APPLICATION NUMBER

5577

**VEHICLE STACKING AND SIDE STREET YARD
SETBACK VARIANCES TO ALLOW NO QUEUING
SPACES FROM THE STREET RIGHT-OF-WAY AT AN
ENTRANCE GATE AND TO ALLOW THE
CONSTRUCTION OF AN ARBOR AND BALCONIES 2'
AND 17' RESPECTIVELY FROM THE SIDE STREET
PROPERTY LINE IN A B-2, NEIGHBORHOOD BUSINESS
DISTRICT; THE ZONING ORDINANCE REQUIRES A
MINIMUM OF THREE VEHICLE QUEUING SPACES
FROM THE STREET RIGHT-OF-WAY AT ENTRANCE
GATES AND A MINIMUM 25' SIDE STREET YARD
SETBACK IN A B-2, NEIGHBORHOOD BUSINESS.**

BOARD OF ZONING ADJUSTMENT

SITE PLAN

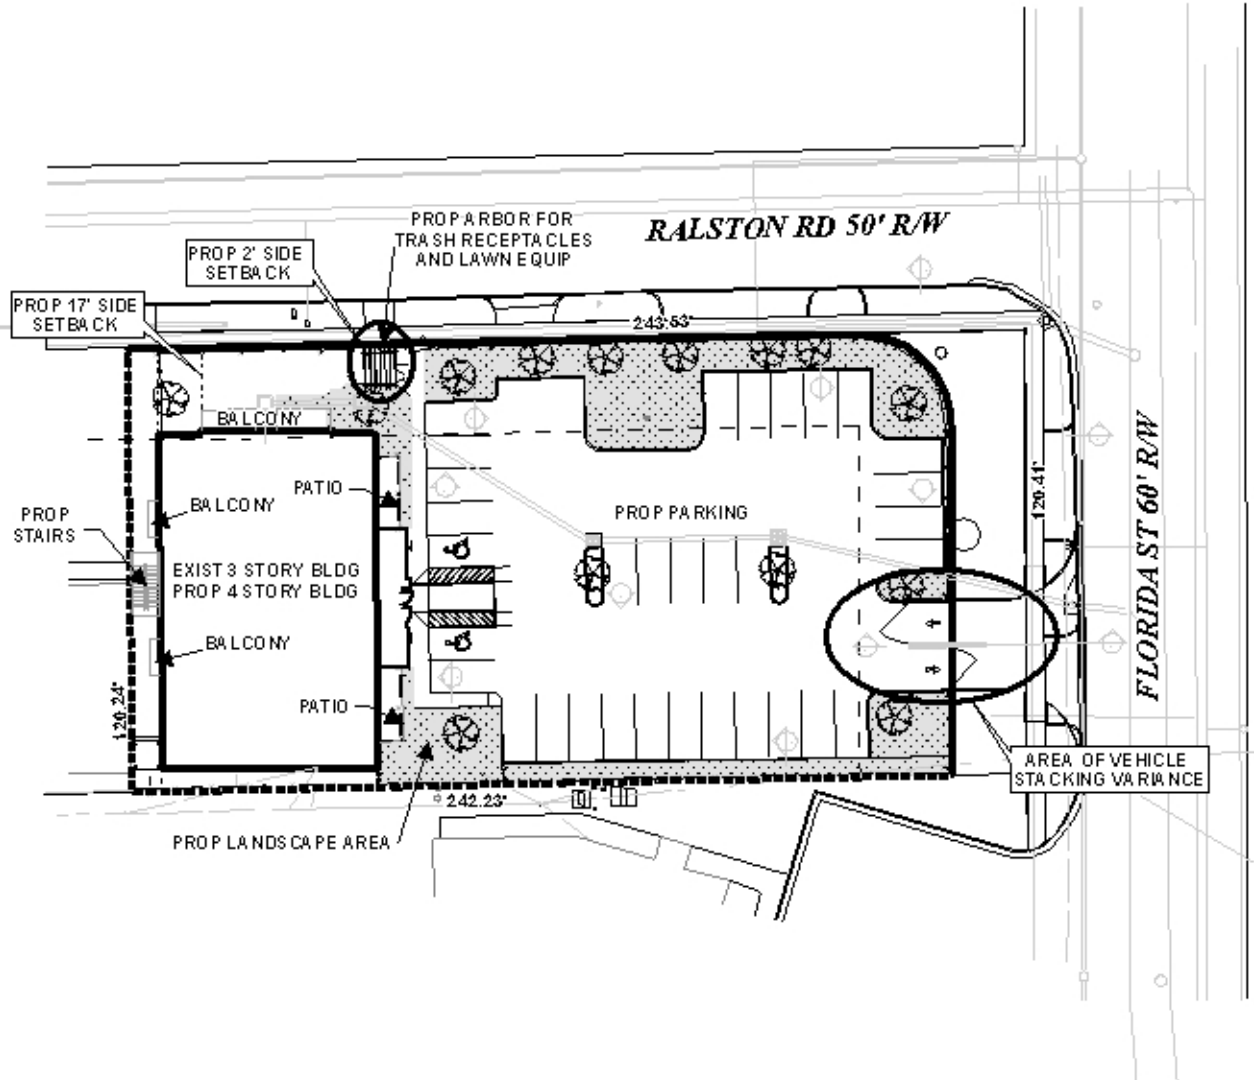
The site plan indicates the entrance aisle gate located approximately 11' from the right-of-way line following dedication required by the subdivision for the site. As three queuing spaces at 17' deep each are required for vehicles waiting to enter the site, this would not allow any on-site queuing spaces. Even including the previous right-of-way would only allow for one queuing space. Vehicle queuing spaces are necessary to insure the protection of the public and community from potentially hazardous and adverse conditions and primarily to prevent vehicles from stacking into the public right-of-way and streets. Also, the site plan indicates that the exit aisle gate swings completely into the public right-of-way. As the site contains 32 parking spaces and 24 are required, the relinquishing of some parking spaces may alleviate this situation.

The applicant proposes to enclose the trash receptacles and lawn maintenance equipment within an 8' by 8' arbor 7' high within 2' of the side street (Ralston Road) property line. The arbor framework and fencing would be of wood with shrubbery and vines attached. Trash collection is proposed by private contract three times per week. The applicant states that due to the location of the existing building and parking requirements, the arbor must be placed in this location. Again, since extra parking is proposed, the relinquishing of one parking space would provide sufficient space for the arbor. Such a space could be provided meeting the 25' setback requirement utilizing the second proposed parking space along the East side of the building South of Ralston Road. Such a location would not only be setback compliant, but would also be located adjacent to the site's sidewalk system and could utilize the same proposed route to the public right-of-way for trash pick-up.

Based upon the preceding, this application is recommended for denial.

BUILDING ELEVATION DETAIL

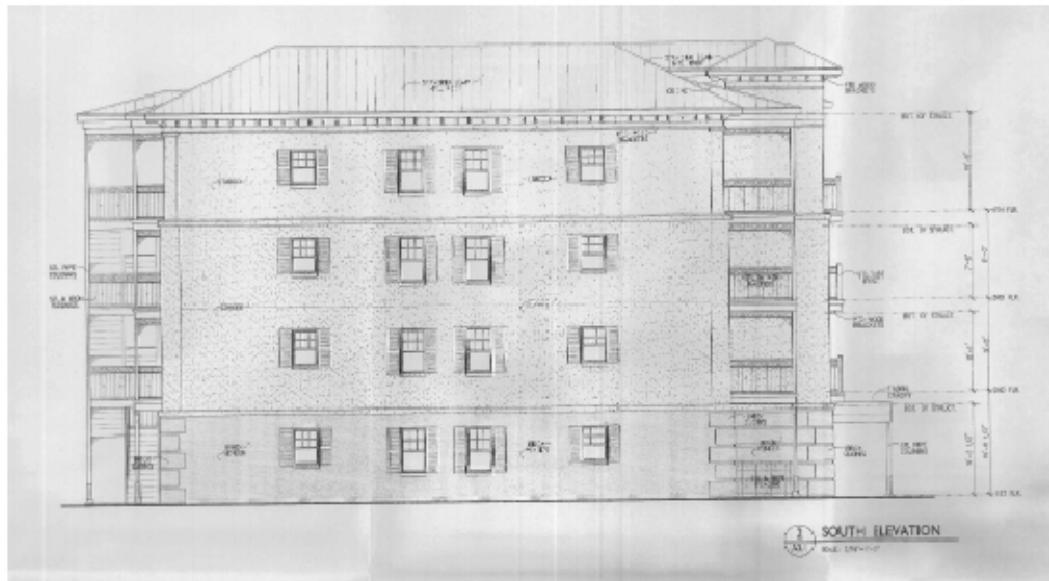
With regard to the setback request for the balconies, the applicant states that the balconies need to be part of the development and will add aesthetics to the surrounding area. It is stated that the existing building extends approximately 2' into the required setback and

that a covered porch extending 6' into the setback has already been removed. Inasmuch as setbacks are intended for the limiting of visibility obstruction, in this instance no structure other than the supporting balcony pipe columns will be installed within the visibility zone below approximately 9' above grade. Although balconies are not necessarily considered a necessity to apartments and condominiums, they do contribute to the opportunities for the residents' enjoyment and would, in this instance, lessen the starkness of an otherwise plain wall and would enhance the streetscape.
